ADA Curb Ramp New Construction Inspection Form (Parallel)

NW Main

23885.56

NW Lenox

PARALLEL RAMP (PL)

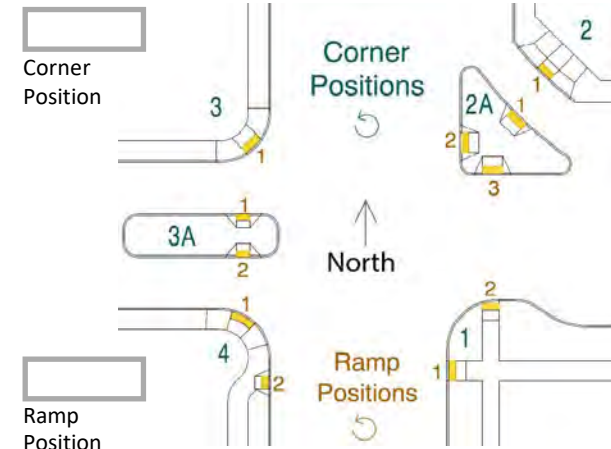
5.3 $\leq *$ ☐ $> *$ ☒

11.1 $\leq 8.3\%$ ☐ $> 8.3\%$ ☒

Comments:
DWS IITD Fails RR 1
